Product Change Notification

Product Change Notification: PCN-23-190234 PCN Date: 20-OCT-23

MAG-MATE 22-20 187 F TAB TPBR

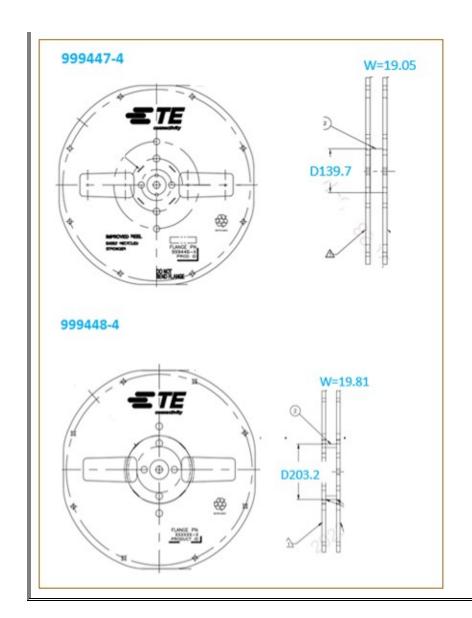
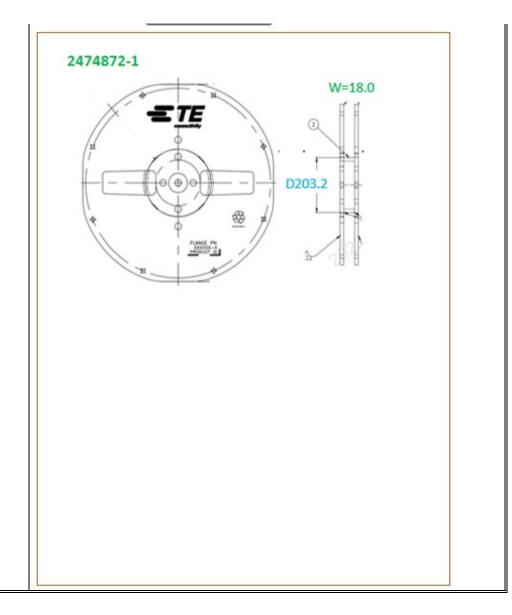
Dear customer we are hereby to inform you reeling PN's have been changed for PN's 62511-2, 62511-1, 62514-2, 62514-1, 63669-1, 63669-2, 1742995-1, 1742474-1, 1742035-1, 1217065-1, 1217128-1, 63663-2, , 63668-1, 63668-2, 63664-2, 63663-1, 63664-1. Please customer also consider shaft width and diameter also changes refer attached file.

Reel PN's 999447-4 & 999448-4 with shaft diameter is 19.81 and width is 114.3 and 177.8 respectively.

After change Reel PN 2474872-1 is with shaft diameter 203.2 and width is 18.0.
